Re: Application for Permit to Drill
Pavant Butte Unit #1
Section 35-19S-7W
Millard County, Utah
Federal Lease #U-19361
Federal Unit Being Formed

APPLICATION FOR PERMIT TO DRILL, DEEPEN, OR PLUG BACK

SUNDRY NOTICES AND REPORTS ON WELLS

(other) Change in Planned Access Road

ARCO OIL + GAS CO
WELL PAVANT BUTTE #1
NW NE SECTION 35, T19S, R7W
HILLARD COUNTY, UTAH

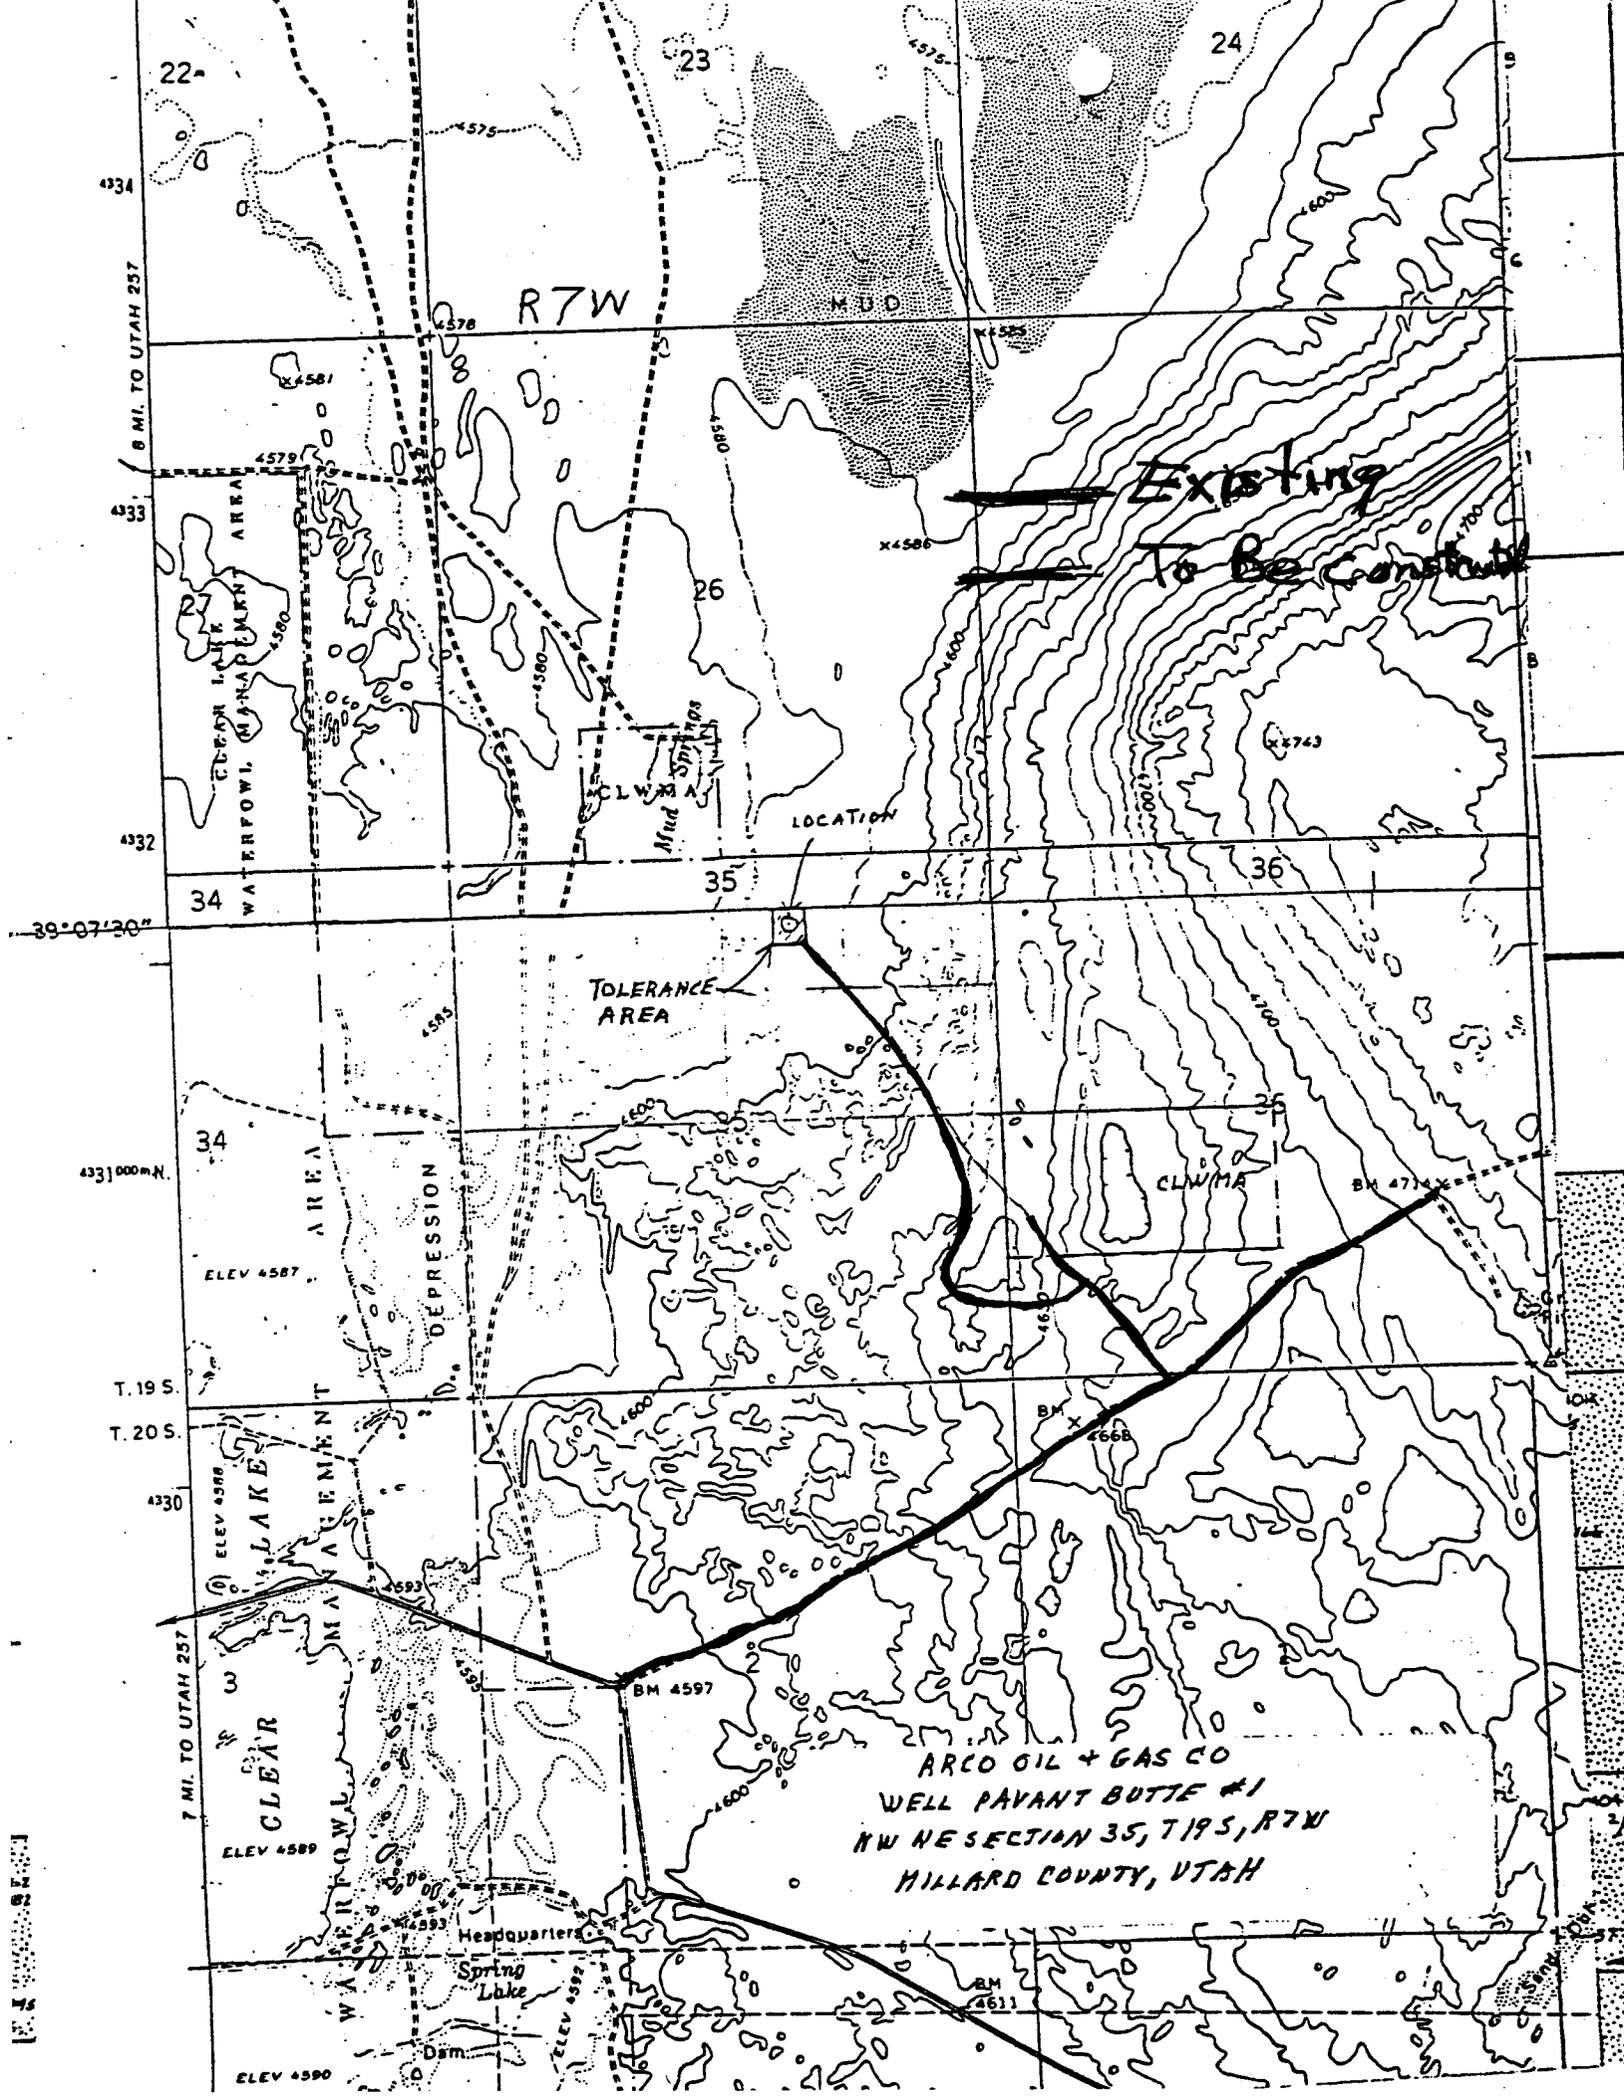
Due to conflicts with the landowner of the 80 acre tract, a portion of the access road was moved. Attached is a map showing the change.

Please attach to No. 2 Planned Access Road on the APD 13 Point Surface Use Plan.

We received the proposed change in access road for ARCO's Well No. 1, Sec. 35, T. 19 S., R. 7 W. We have no objections to the proposed change. We have been assured by Fred Frampton that the route has been cleared for cultural resources.
